## Inspection Report of 5419 Fleming Way Stuart FL 34997 Prepared for Stella Luongo

Inspection Report of 5419 Mosley Stuart Fl 34997 for Stella Luongo 7.20.06

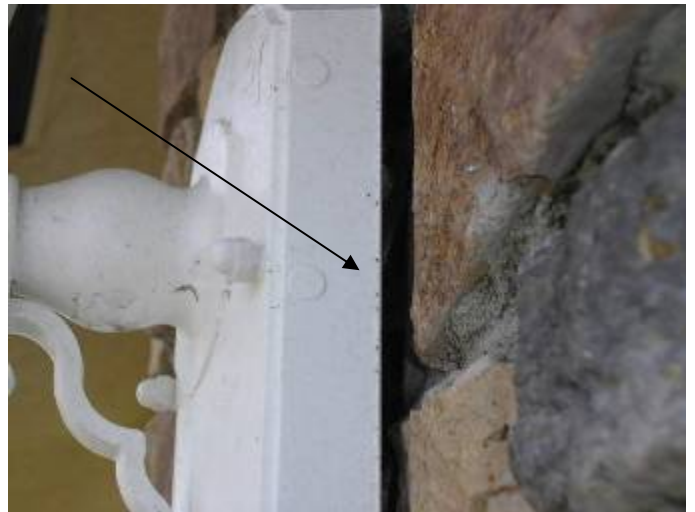
There are visible/exposed wires & the exterior light fixtures are not completely sealed or gasketed at the base as required. §13-606.1.ABC.1.2

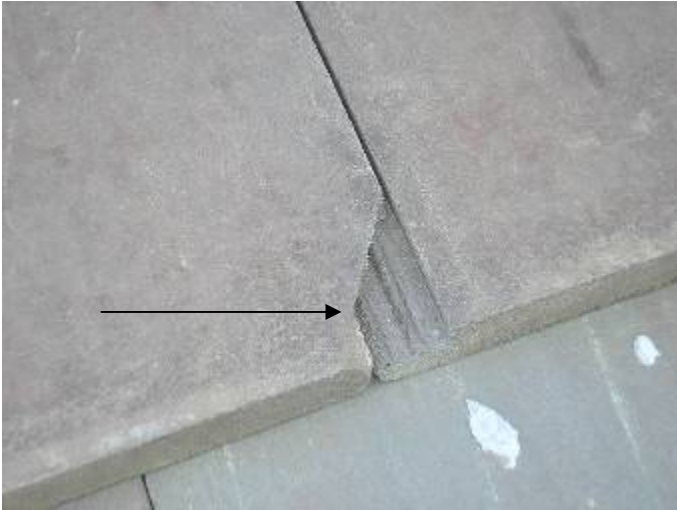
There were broken & incorrectly repaired roof tiles at several locations. The broken roof tiles should be removed & replaced, not "glued" back together.

**Broken roof tiles cannot be "glued" back together**

**Thanks for your inquiry regarding our products. RT600 is specified for replacing an entire tile, not for gluing a broken tile back together. Please email or call (800) 624-7767 with any questions. Sincerely, BHeineking OSI Sealants / Tech Service**

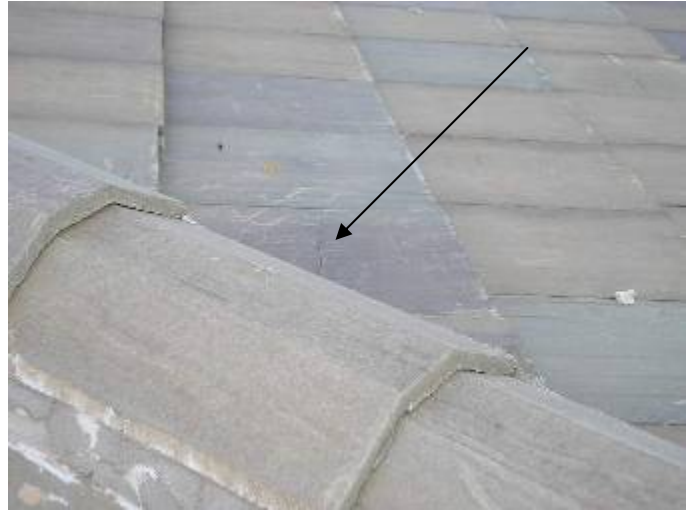
There were broken & incorrectly repaired roof tiles at several locations. The broken roof tiles should be removed & replaced, not "glued" back together.

There should not be any broken tiles on the new roof. The tiles need to be removed & replaced; not "glued" back together.

Some of the tiles are loose &/or have slipped out of place. All loose tiles need to be correctly secured.

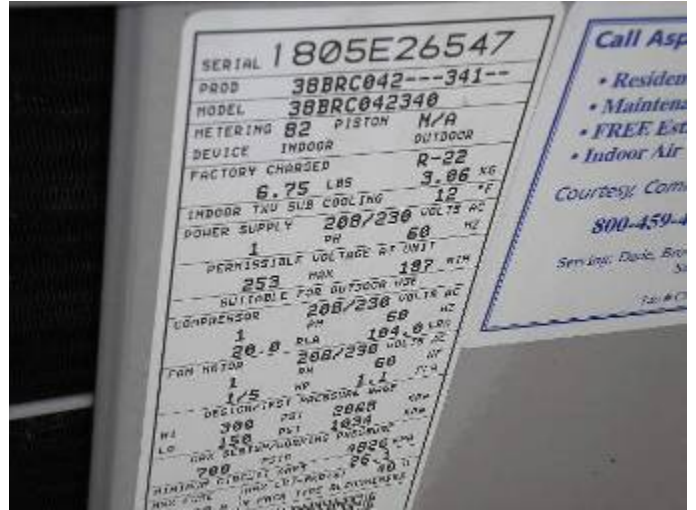
The strapping is loose & not correctly secured at some of the landscape trees.

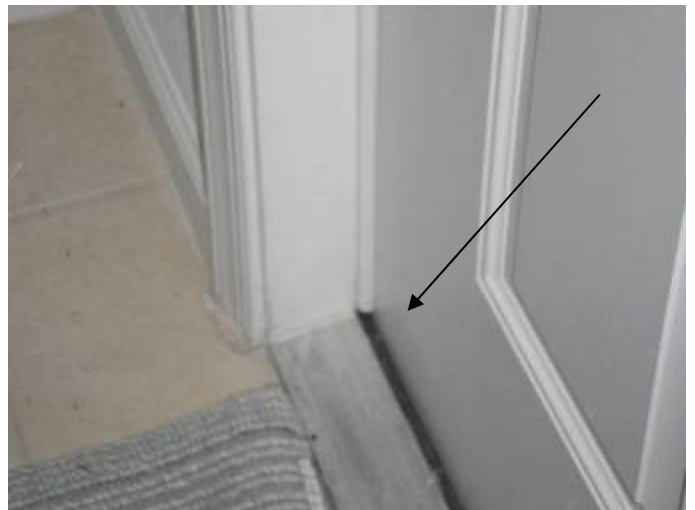
The south side sliding glass door did not open & close correctly.

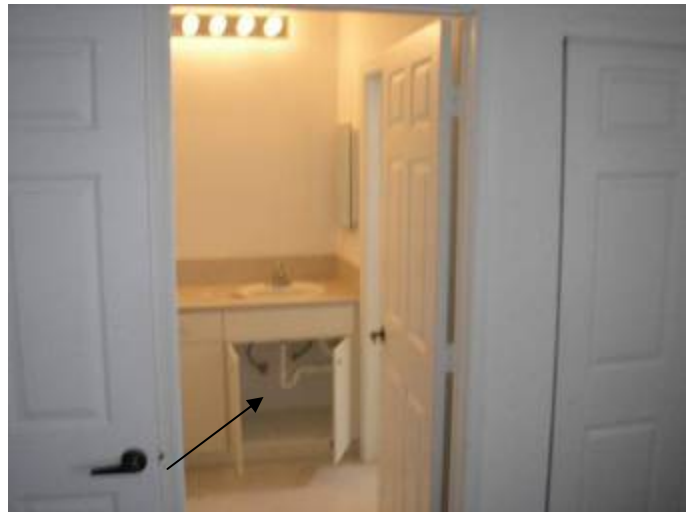
The drywall is not correctly finished or painted as required inside the master bathroom linen closet above the top of the door frame.

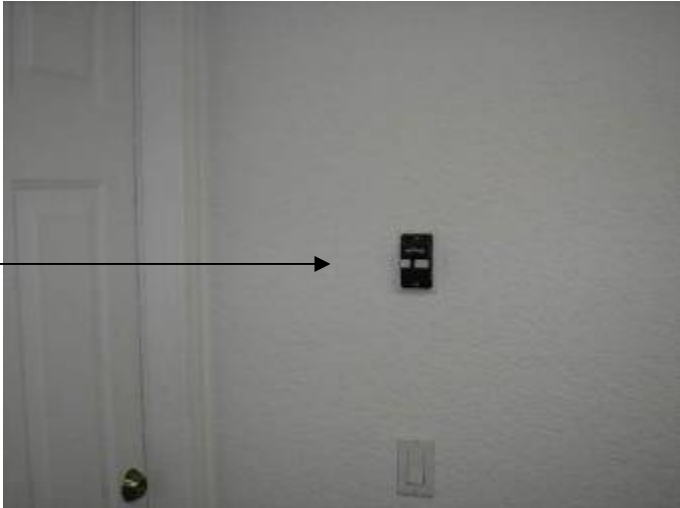
Some of the plumbing supply piping is loose & not correctly secured at the sink cabinets & behind the walls at the water closets (toilets).

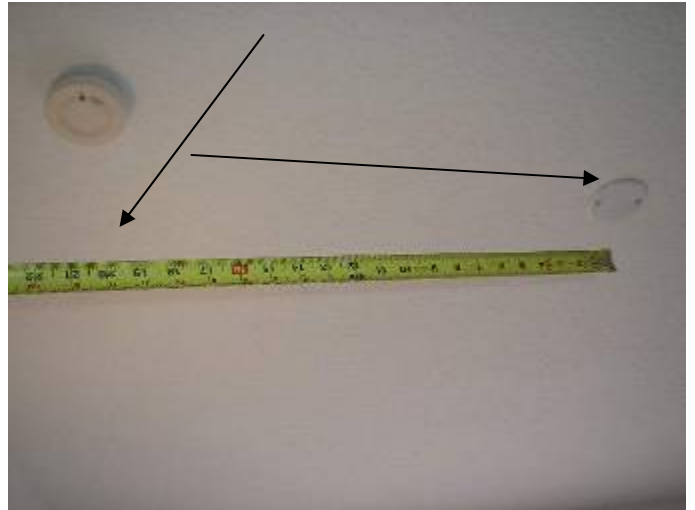
The thin aluminum foil dryer vent duct material is a fire hazard per CSPC & the manufacturer. See warning label on back of the dryer. §M304.1

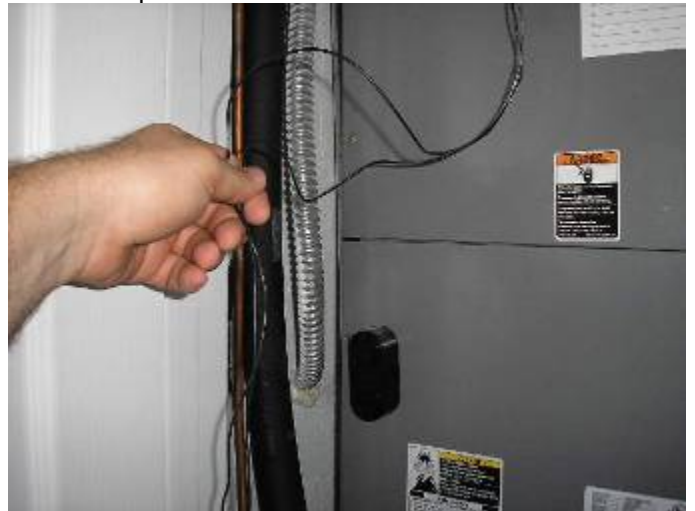
The smoke detectors are located too close to the ceiling fan junction boxes in the bedroom. 3' clearance from the fan blade tips should be allowed.

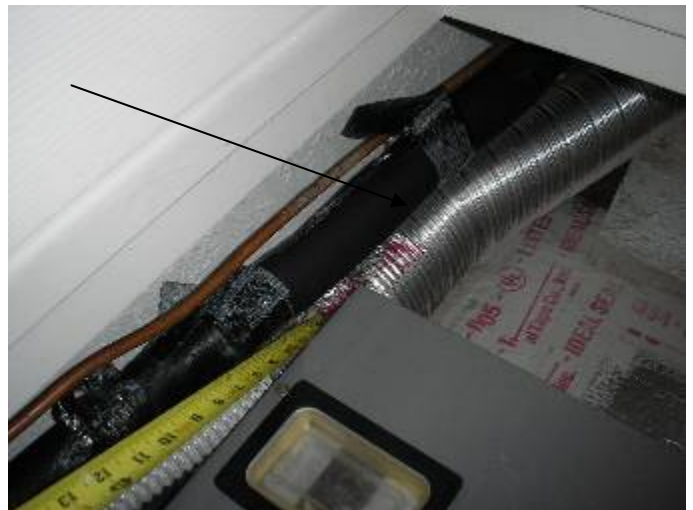
The AC mechanical closet is not completely sealed as required. §13-410.1.ABCD.3.7

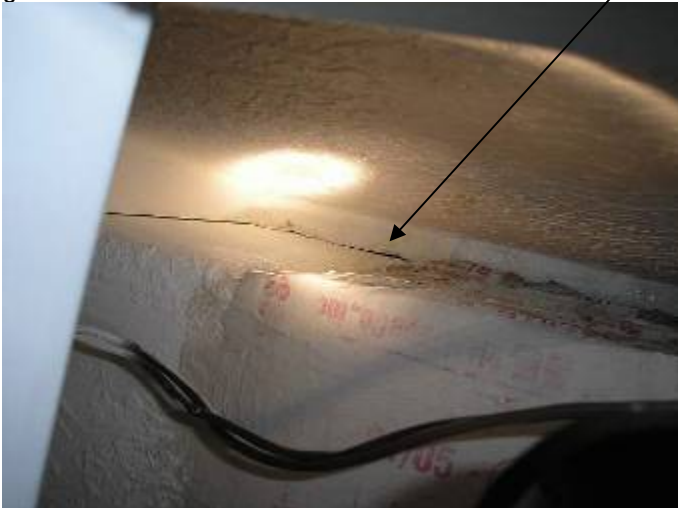
There is not enough space around the air handler at the back of the unit. 4 inch clearance is required. §M603.1.3 §13-410.1.ABCD.3.0.3

There is not enough space around the air handler at the back of the unit. 4 inch clearance is required. §M603.1.3 §13-410.1.ABCD.3.0.3

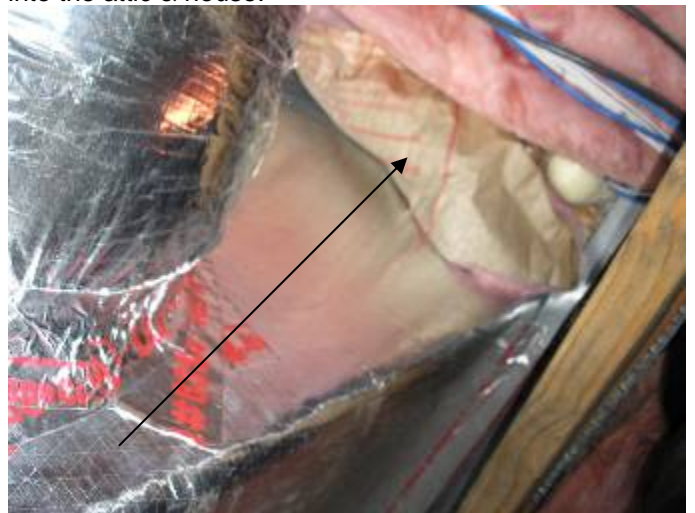
The area around the exhaust vent ducting is not sealed to prevent water & pest intrusion into the attic & house.

Camera flash off. The area around the exhaust vent ducting is not sealed to prevent water & pest intrusion into the attic & house.

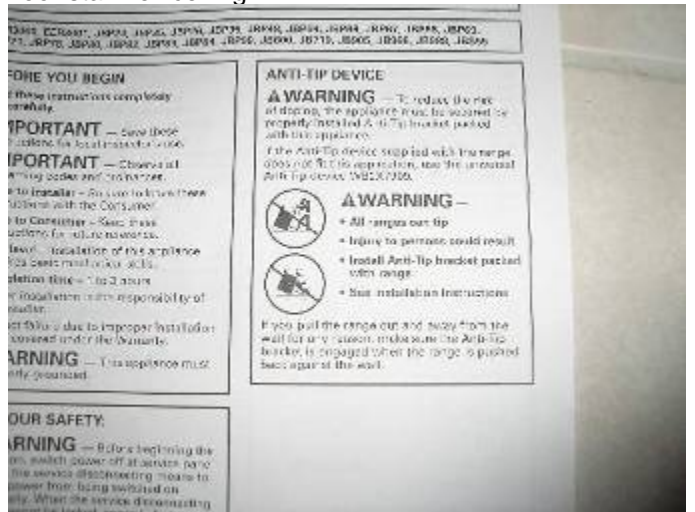
The fire sprinkler cap appears to be sealed in place & would not work in the event of an emergency.

The fire sprinkler cap appears to be sealed in place & would not work in the event of an emergency at the 2<sup>nd</sup> floor stairwell ceiling.
